Groundwater Transfer Review Summary Form

Transfer/PA # T- 14113

Application: T-14113

Applicant Name: Oregon Parks and Recreation Dept

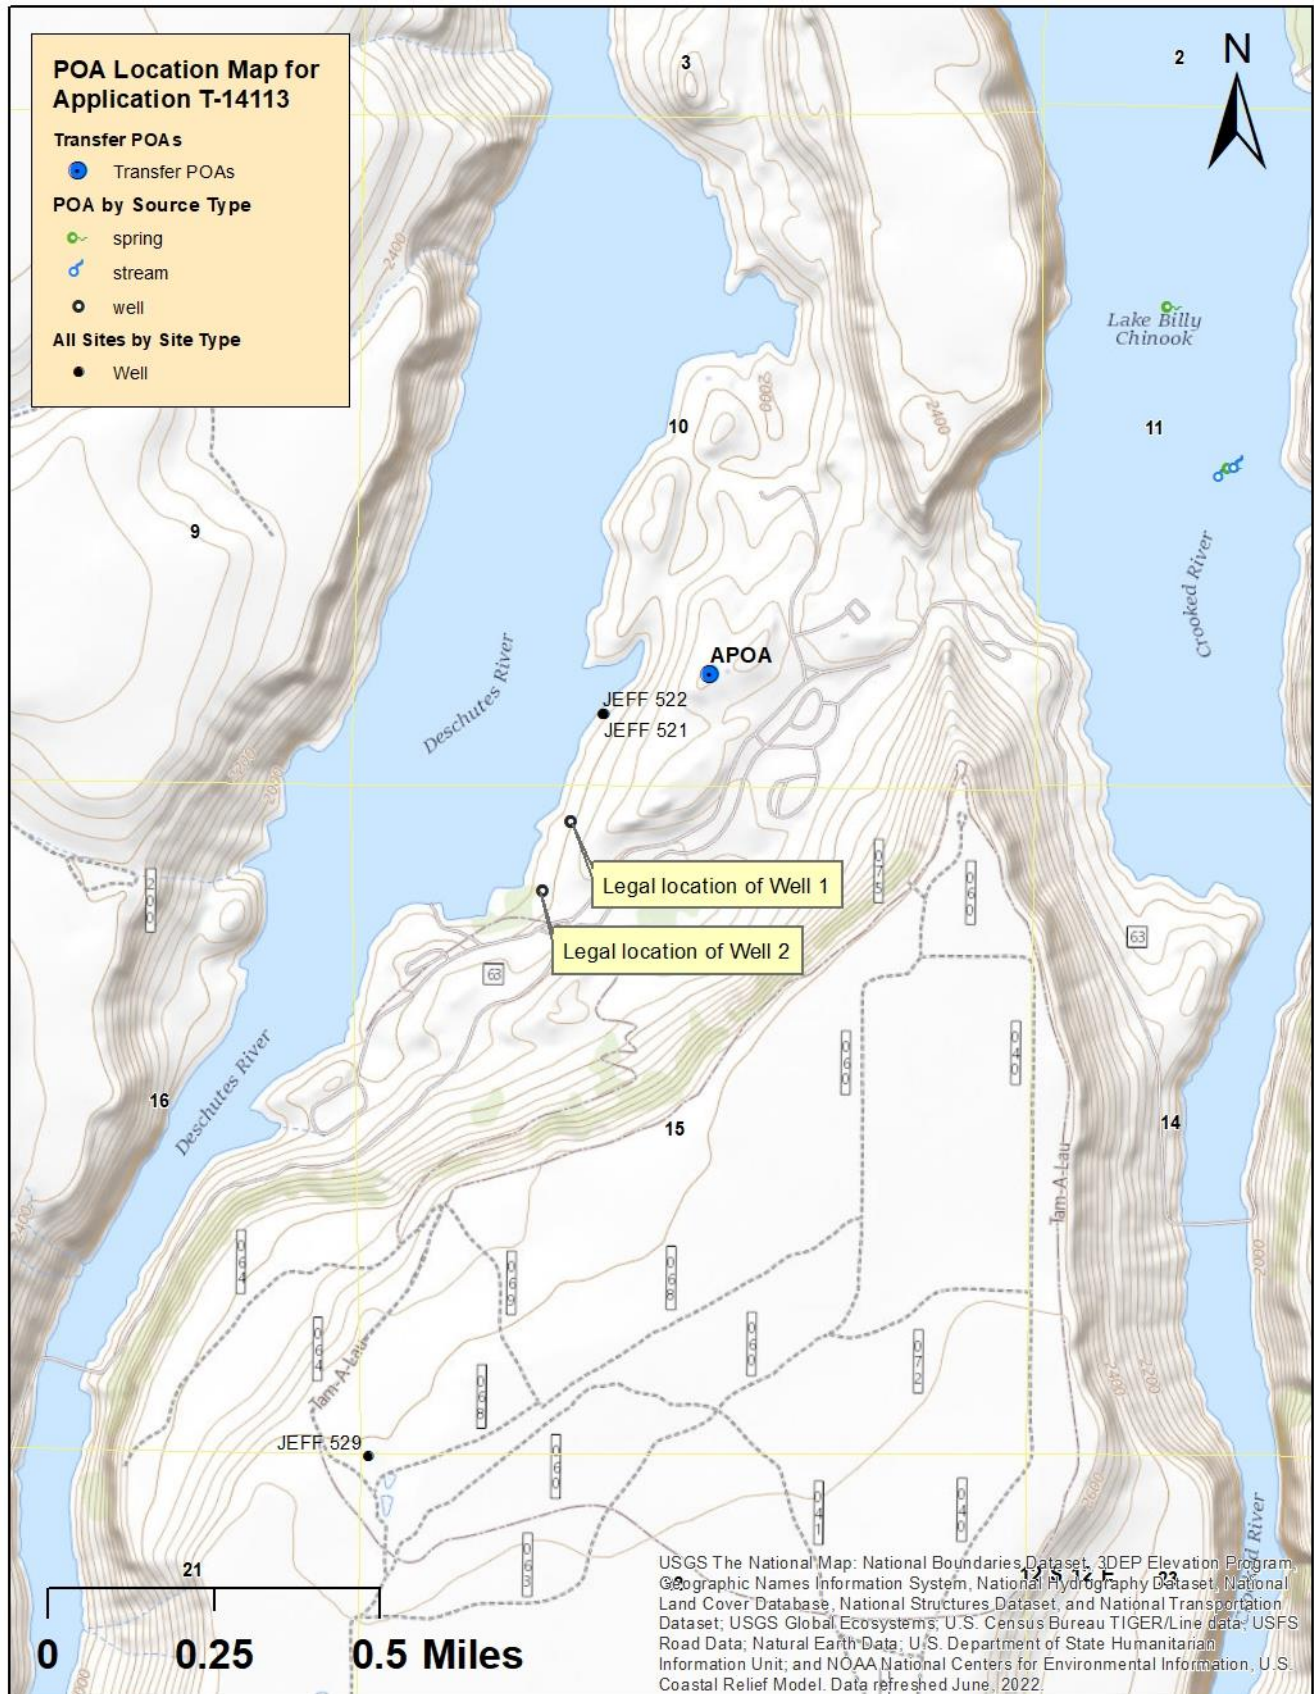
USGS OFR 97-197 (Caldwell and Truini, 1997) indicate that two wells were located during field visits. This publication correlates the visits to JEFF 521 and JEFF 522. Depth to water was measured at 12.65 and 11.26 feet BLS respectively. The location of these wells is in 12S/12E section 10, however. Additionally, 2005 applications for Well ID Tags indicate that JEFF 521 and JEFF 522 are located in section 10.

Lastly, aerial imagery shows infrastructure at the well locations provided in OFR 97-197 but no infrastructure at the legal locations of Well 1 and Well 2 of certificate 39065.

In conclusion, best available information indicates that its unlikely that well logs JEFF 521 and JEFF 522 correspond to wells constructed at the legal POA locations under certificate 39065. If there is groundwater production at the legal locations, the SWLs should 50-100 feet BLS and those wells would not likely correspond to JEFF 521 and JEFF 522. If those are the correct well logs, then the wells are not located in the location specified by certificate 39065.
